Access Compliance Report

Public Rights-of-Way

Intersection ID: 28033	Main Street: LOWER_SHOAL_CREEK_CT	Cross Street: SHOAL_CREEK_CT	Location: E
ADA ID: AEE23F119B9E	Ramp Type: BlendTrans2	Initial Pass/Fail: Fail	Overall Compliance: No
		Severity Score: 8.75

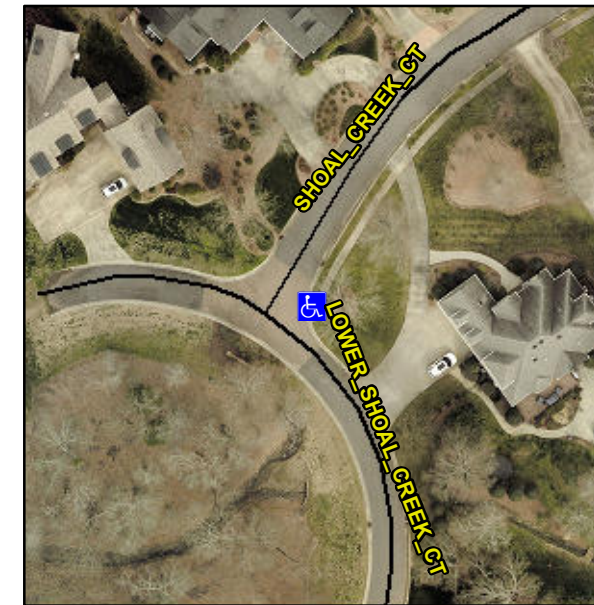
Not Found, R304.5.1

Compliance	Description	Data	Compliance	Description	Data
N/A	Ramp Length (in)	95.0	Yes	BlendTrans Slope (%)	4.7
No	Ramp Width (in)	39.0	Yes	BlendTrans XSlope (%)	0.4
N/A	Flare Type LT	N/A	N/A	Flare Type RT	N/A
N/A	Flare Slope LT (%)	N/A	N/A	Flare Slope RT (%)	N/A
N/A	Flare Traversable LT?	N/A	N/A	Flare Traversable RT?	N/A
N/A	Landing Length (in)	N/A	N/A	DWS Provided?	N/A
N/A	Landing Width (in)	N/A	N/A	DWS Contrast?	N/A
N/A	Landing Slope (%)	N/A	N/A	DWS Length (in)	N/A
N/A	Landing X Slope (%)	N/A	N/A	DWS Full Width?	N/A
N/A	Landing Curb? (Y/N)	N/A	N/A	DWS Offset (in)	N/A
N/A	Shared Landing?	N/A			
N/A	Gutter Ponding?	N/A	N/A	Gutter Slope (%)	N/A
N/A	Gutter Lip Ht (in)	N/A	N/A	Gutter X Slope (%)	N/A
N/A	Painted X Walk1?	No	N/A	Painted X Walk2?	No
	X Walk 1 Direction	To NW		X Walk 2 Direction	To S
	X Walk 1 Width (in)	N/A		X Walk 2 Width (in)	N/A
	X Walk 1 Slope (%)	N/A		X Walk 2 Slope (%)	N/A
	X Walk 1 X Slope (%)	N/A		X Walk 2 X Slope (%)	N/A

N/A	Ramp inside XWalk1?	N/A	N/A	Ramp inside XWalk2?	N/A
	Road Slope (%)	0.7		Clear Space?	N/A
	Road X Slope (%)	0.6	N/A	Clear Space to XWalk (in)	N/A
N/A	Any Obstructions?	N/A	N/A	Storm Grate/Utility Hazard?	N/A
	Obstruction Type			Storm Grate/Utility Type	
		N/A			N/A
			Yes	Surface Condition? (G/P)	Good
			No	Curb Slope (%)	11.1

Remove & Replace Curb Ramp With Two New Directional Ramps or Equivalent.
